SERVICE TECHNICAL INFORMATION

ONE POINT REPAIR

MODEL : HS-JS445

SUBJECT : Noise occurred during radio recording

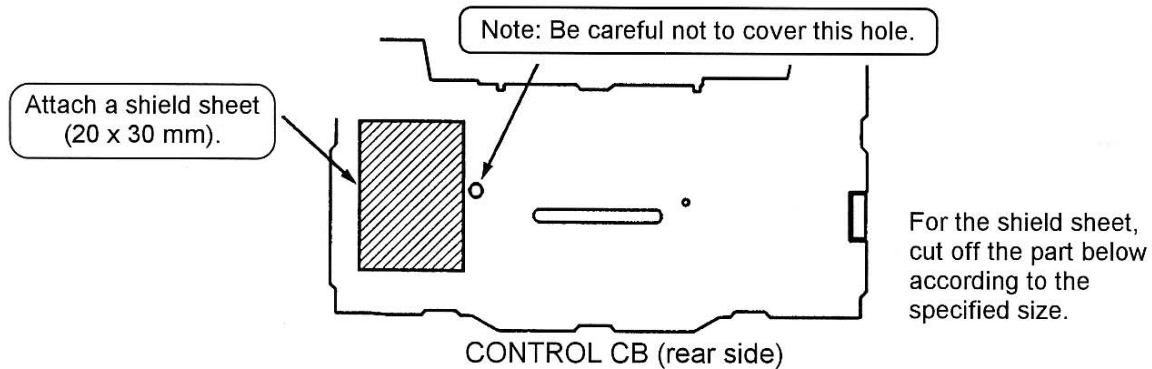
CONTENTS : When sound recording on radio mode is made with the above model, "peep" sound (REC BEAT) may be recorded. If such a symptom is indicated, perform the remedy below.

REMEDIES : ① For noise during FM reception

As shown in the figure below, solder the wire to the body of X'TAL (X301) of the CONTROL CB and connect the body to GND of C327.
